Part A Panel Report

Whittlesea Planning Scheme Amendment C187 Wollert Precinct Structure Plan

1 April 2016

Figure 3: Proposed modification to APA GasNet Buffer Area.

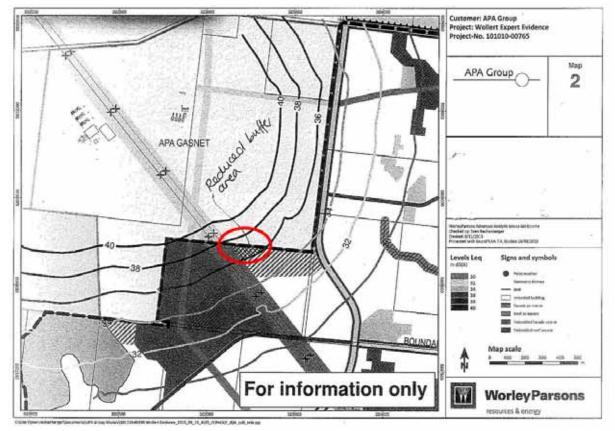
Council noted that while the exhibited PSP designates some land as a potential future buffer for the Gas Fired Power Station it shows the underlying land use as residential purposes. In effect, if a power station proposal does not eventuate, or is not deemed to have the amenity impacts envisaged by preliminary noise assessments, the land may be considered for residential development. Council considers the approach is appropriate because it protects the potential for the facility, but makes it clear what the land use would have been otherwise.

Villawood and Evolve initially submitted that the buffer area should be removed from the Future Urban Structure Plan given that there are not current proposals by APA GasNet and that it is APA's GasNet's responsibility to assess and undertake all amenity mitigation measures on its site rather than impacting on UGZ land. This position changed after consultation between the APA Group and the Consortium before to the Hearing. The Panel was advised by the Consortium (Document 46, Para 64) that an agreement had been reached between the APA Group and the Consortium regarding the appropriate buffer controls to put in place. APA confirmed (Document 36(a), Para 5(i)) that agreement had been reached between it and the Consortium to modify Future Urban Structure Plan within the PSP to show a reduced Buffer Area as shown in Figure 3.

- 5 Change Plan 2 to reduce the 'potential future gas fired power station buffer' so that it only applies to land identified as future 'residential' that is above the modelled 36 dB(A) contour as shown on the APA Group 'Map 2' prepared by Worley Parsons.

Figure 10: Evolve Identified 'Undevelopable Land'

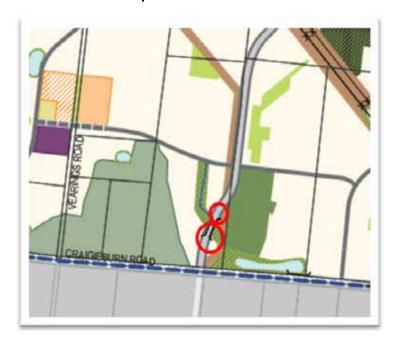
Evolve is concerned that the PSP design creates two small areas of land between the north-south gas easement and the future Koukoura Drive alignment (see Figure 10: Evolve Identified 'Undevelopable Land'). Evolve submitted that the design be reviewed as the two parcels are not large enough to accommodate residential development. Evolve considered that a practical solution would be the use of the land for open space or drainage, which it submits would allow the northeast corner to the Craigieburn Road/Koukoura Drive intersection to be used as a green area into the development, softening the appearance of the intersection and arterial road interface.
